# Request for Information

**Project:** Ocean Discovery  
**Title:** Solar Scope Clarification  
**From:** Soltek Pacific  
**To:** Rob Wellington Quigley  
**Plan Ref:**

**Document:** **No. 0206**  
**Sub Ref. No.:**  
**Date:** 10/26/2016  
**Required Date:** 11/02/2016  
**Response Date:**

REVISIONS SHEET NO.  
E3.7  
OF SHEETS

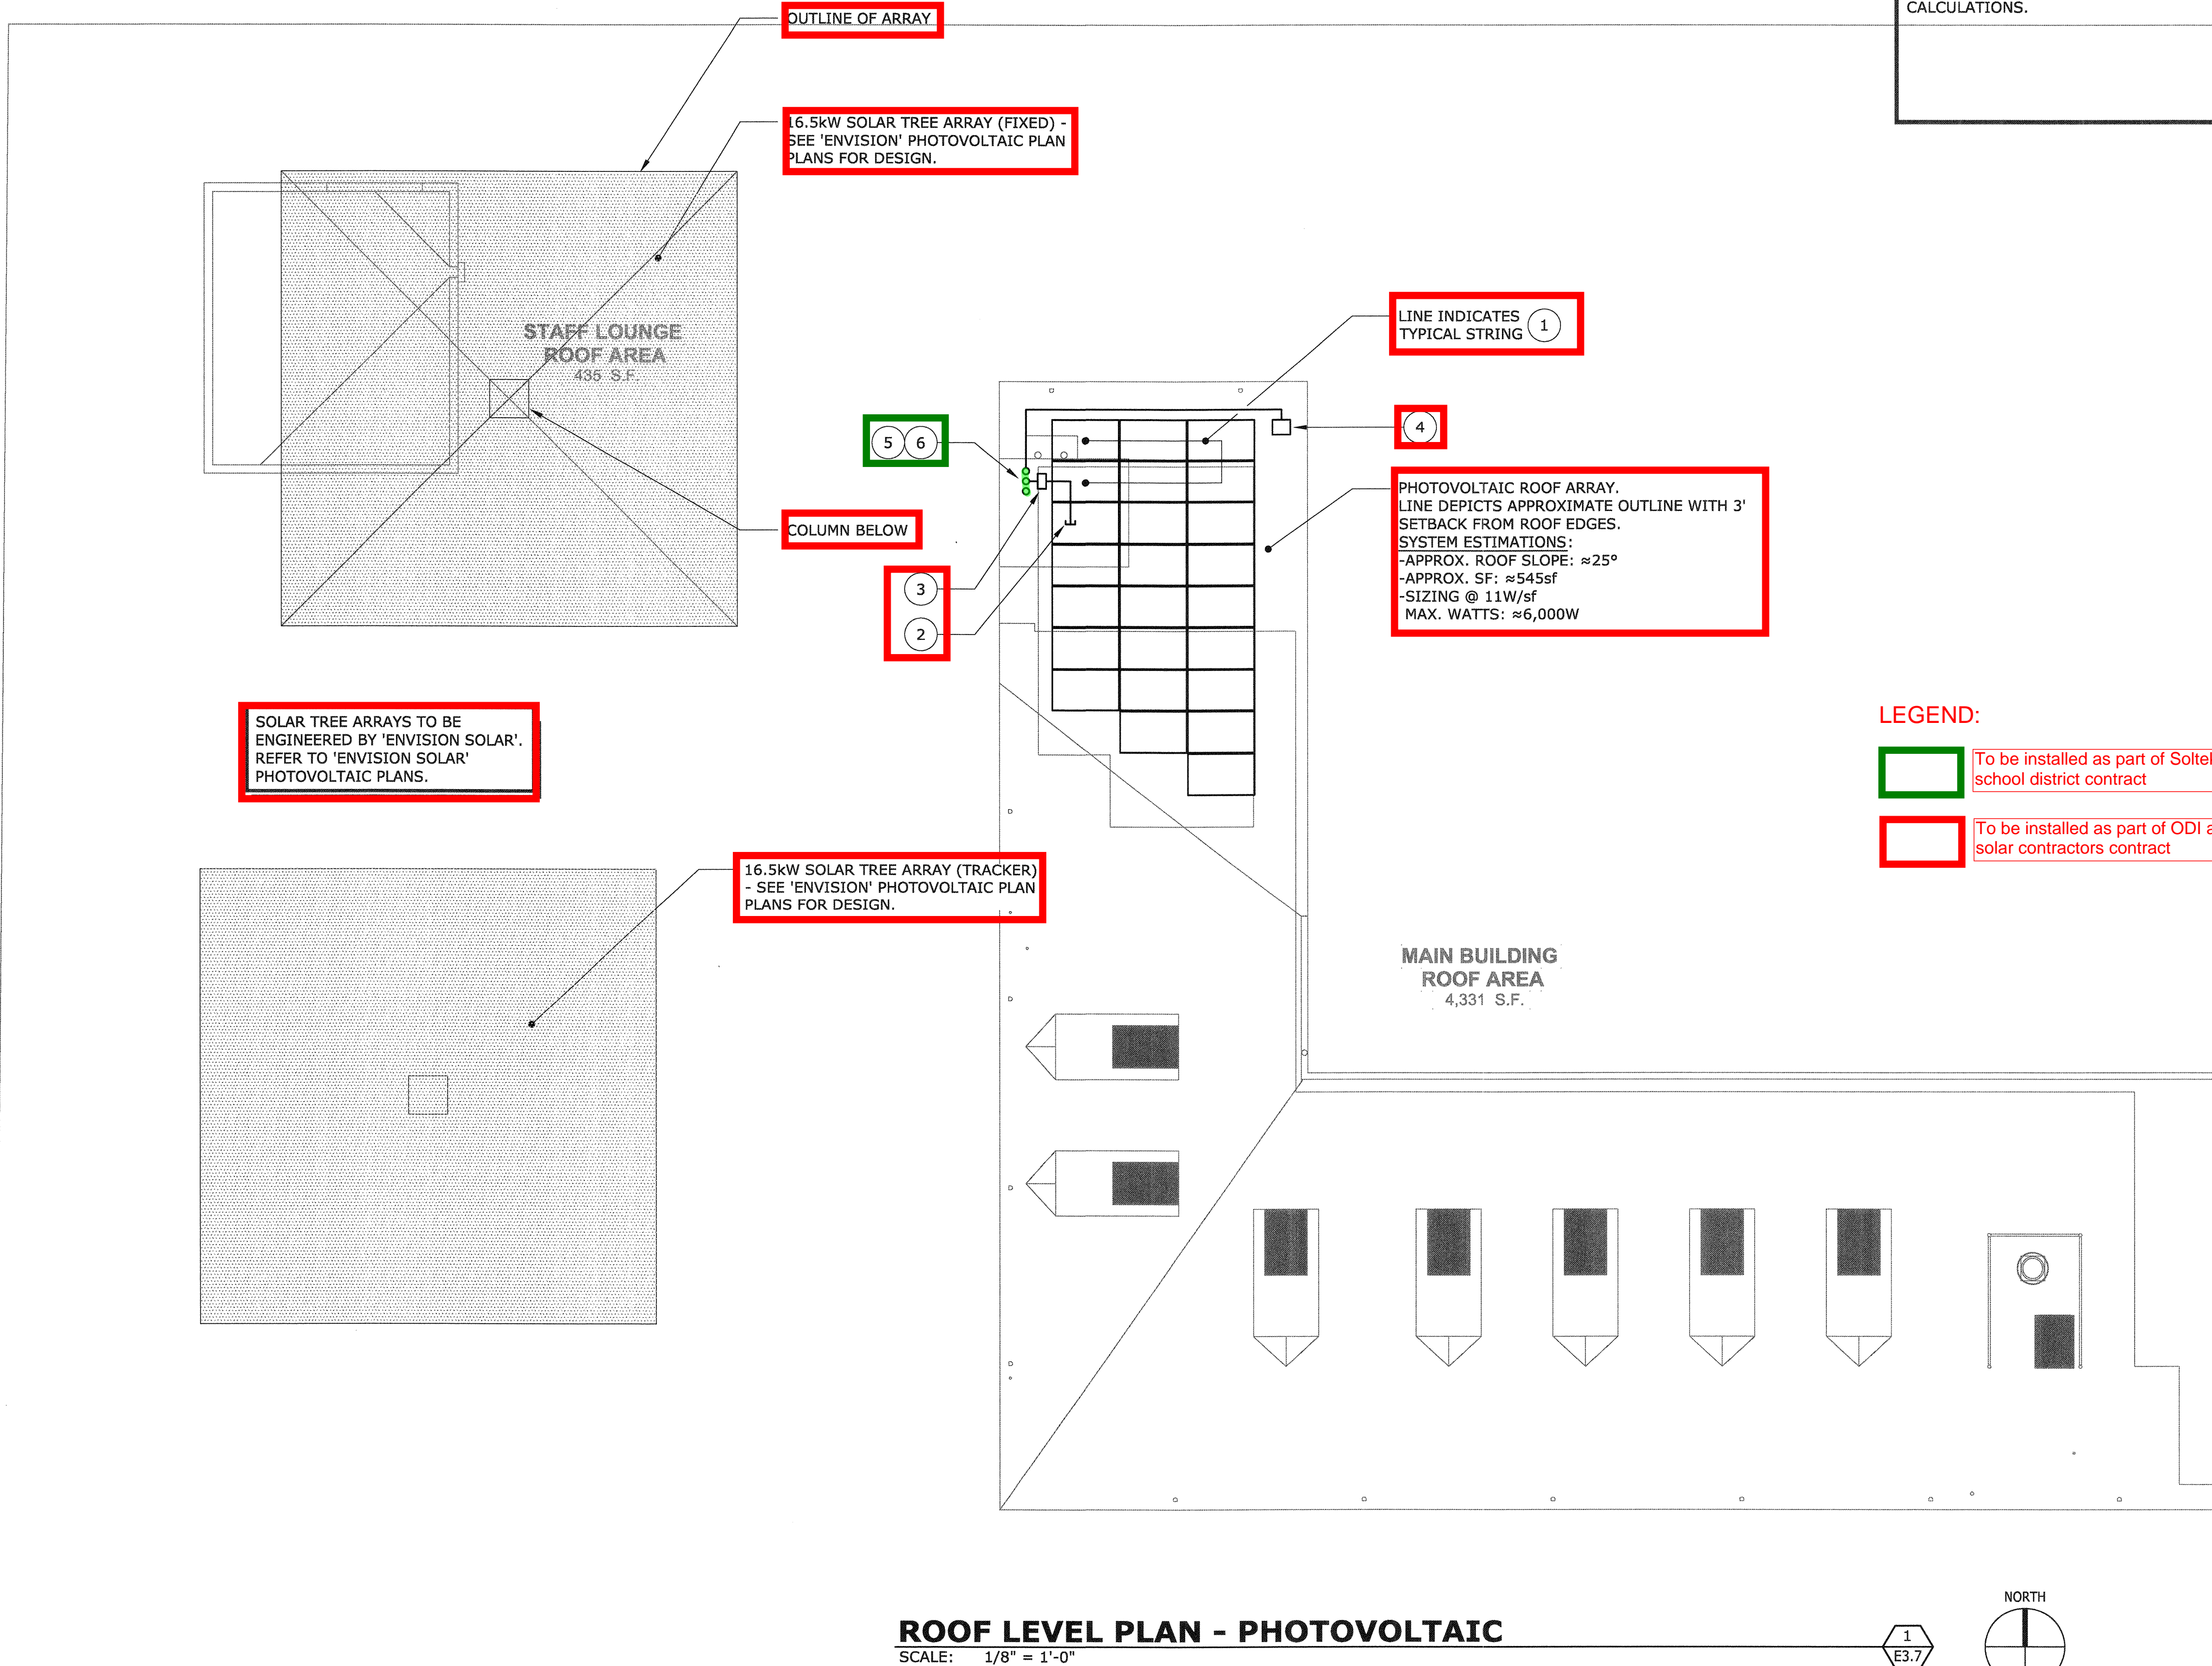
Assuming the solar/PV system is remaining the same size as the basis of design per drawing sheet E3.7 , PARs interpretation of the drawings and scope of work at bid time for the solar portion of work is as follows:

REVISIONS		SHEET NO.		E4.1	
				OF SHEETS

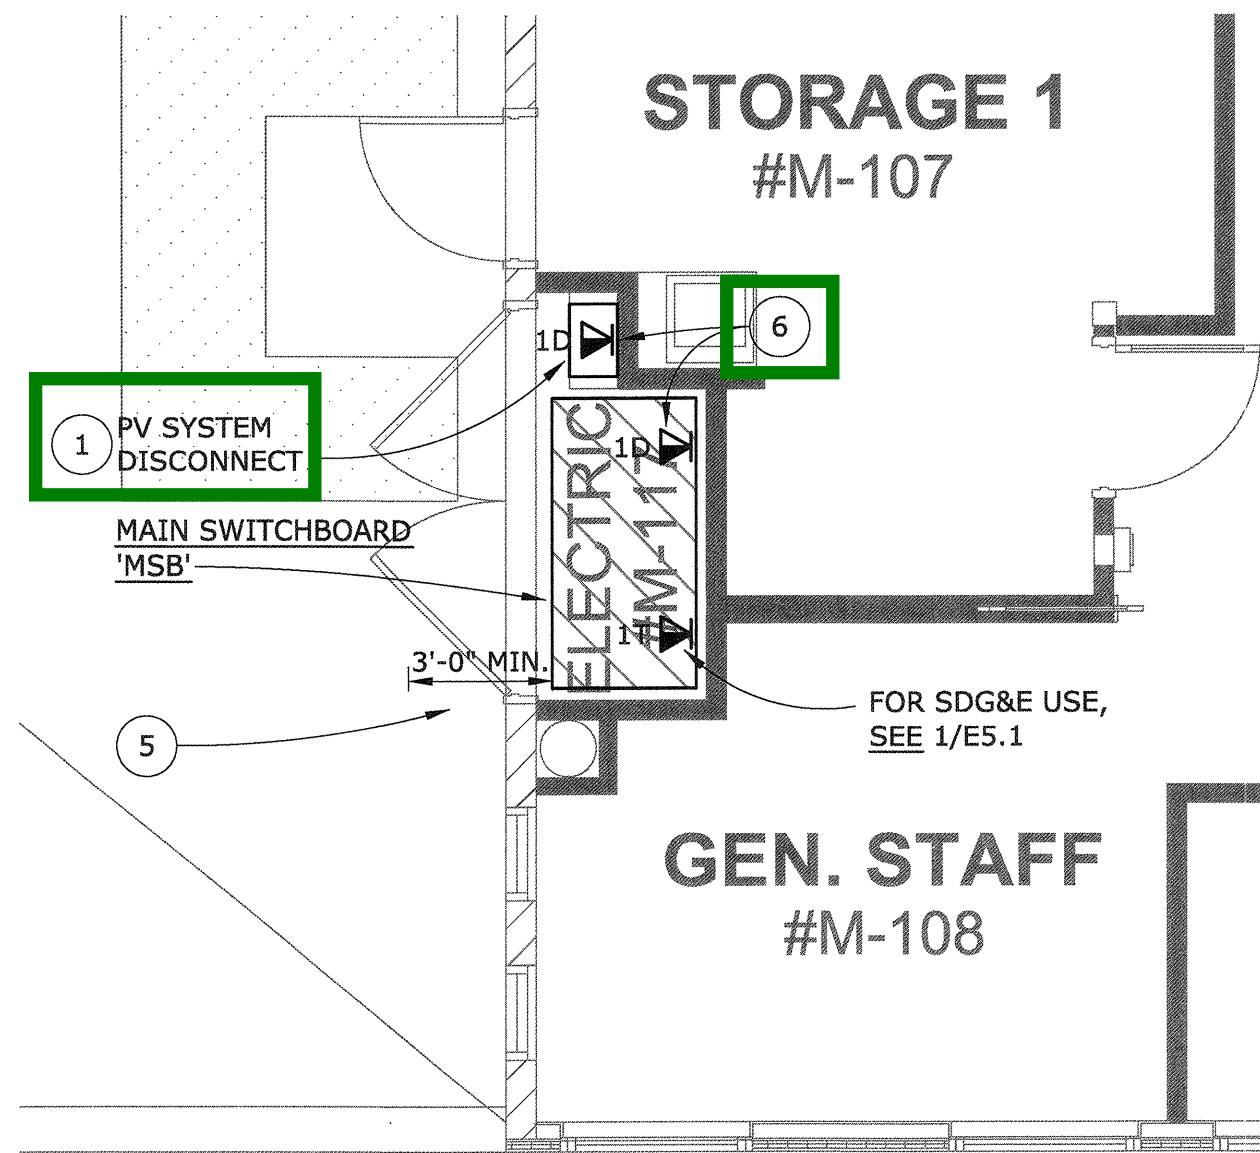
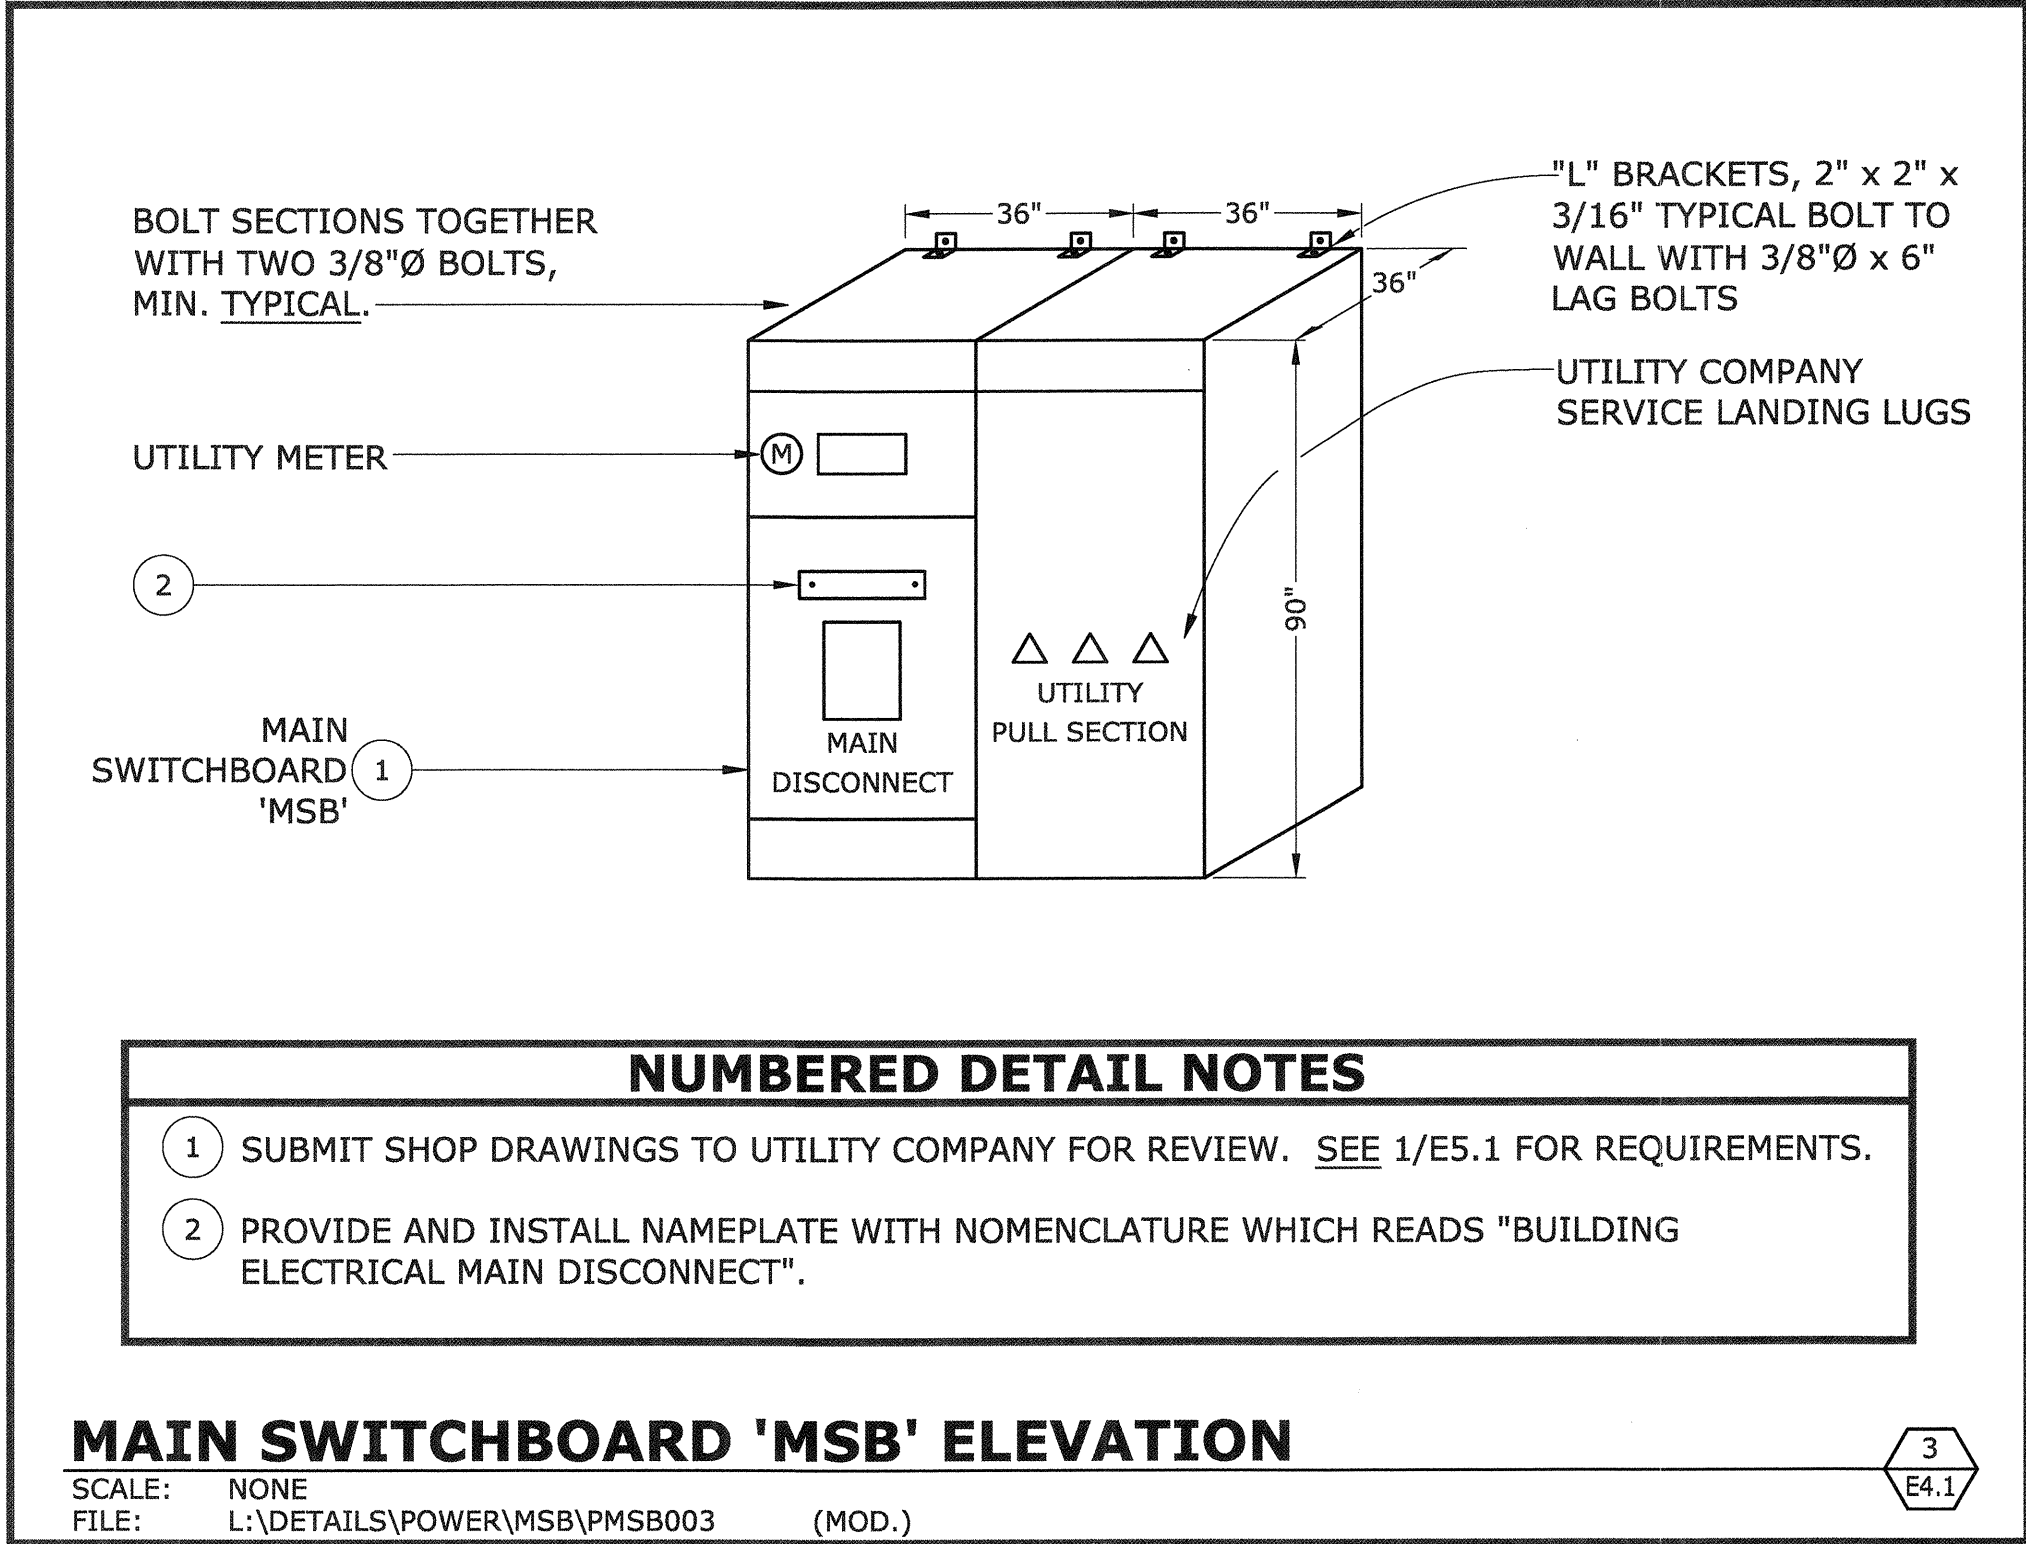
- Procurement and installation of conduit and wire from MSB to PV system disconnect, (4) 4/0 +(1) #4G in (1) 3 " Conduit
- Procurement and installation of PV system disconnect, installed at the location shown on drawing E4.1
- Procurement and installation of conduit and wire from PV disconnect to Panel PV, (4) 4/0 +(1) #4G in (1) 3 " Conduit
- Procurement and installation of panel " PV " as shown on Sheet E5.7 and E4.1
- Procurement and installation of conduit as described per Note 6 on E3.7, (1) 1 ¼ " conduit for string wiring, (1) 1 ¼ " conduit for spare capacity, and (1) ¾ " conduit for communications to MET station. Exact roof penetration location to be determined by architect and conduit shall be stubbed into the electrical room (C-006). Conduit stubbed through the roof will be capped off and made water tight for future use by others (solar installer)

- Procurement and installation of conduit and ~~wire~~ from MSB to PV system disconnect, ~~(4) 4/0 + (1) #4G~~ in (1) 3" Conduit
- Procurement and installation of PV system disconnect, installed at the location shown on drawing E4.1
- Procurement and installation of conduit and ~~wire~~ from PV disconnect to Panel PV, ~~(4) 4/0 + (1) #4G~~ in (1) 3" Conduit
- Procurement and installation of panel "PV" as shown on Sheet E5.7 and E4.1
- Procurement and installation of conduit as described per Note 6 on E3.7, (1) 1 1/4" conduit for string wiring, (1) 1 1/4" conduit for spare capacity, and (1) 3/4" conduit for communications to MET station. Exact roof penetration location to be determined by architect and conduit shall be stubbed into the electrical room (C-006). Conduit stubbed through the roof will be capped off and made water tight for future use by others (solar installer)

- To be installed as part of Soltek's and school district contract
- To be installed as part of ODI and solar contractors contract
